UNITED STATES PATENT AND TRADEMARK OFFICE

APPLICATION NO.	FILING DATE	FIRST NAMED INVENTOR	ATTORNEY DOCKET NO.	CONFIRMATION NO.
10/790,102	03/02/2004	Ming-Feng Wu	MR957-1466	1209
4586	7590	10/27/2005		
ROSENBERG, KLEIN & LEE 3458 ELLICOTT CENTER DRIVE-SUITE 101 ELLICOTT CITY, MD 21043			EXAMINER MAGUIRE, LINDSAY MONICA	
			ART UNIT	PAPER NUMBER
			3634

DETAILED ACTION

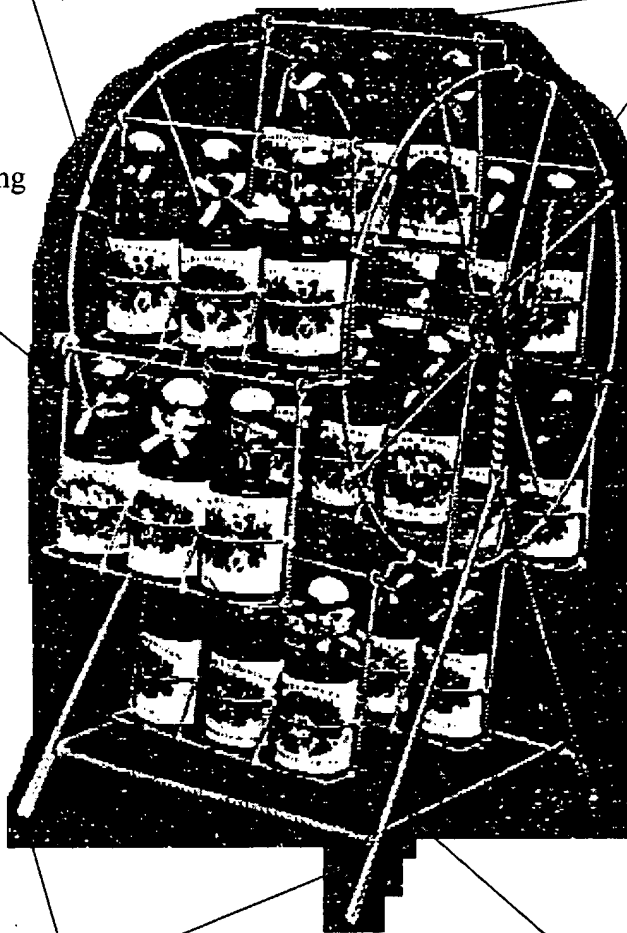
Spencer discloses a rack for holding objects on, comprising a main frame (4) having lateral supporting portions (3) at two ends; two rotary frames (2) pivoted to respective ones of the lateral supporting portions of the main frame; and a plurality of holding rack parts (5) each pivoted to the rotary frames at two ends thereof; each of the holding rack parts having a plurality of receiving holes (1) thereon for objects to be passed through (see attached sheet for Figure & reference numbers). In addition, Spencer also discloses that each holding rack has a plurality of rings connected together (5 and 1) for providing the receiving holes.

Receiving Holes (1)

Rotary Frames (2)

Holding
Rack
(5)

Lateral Supports
(3)

Main Frame
(4)
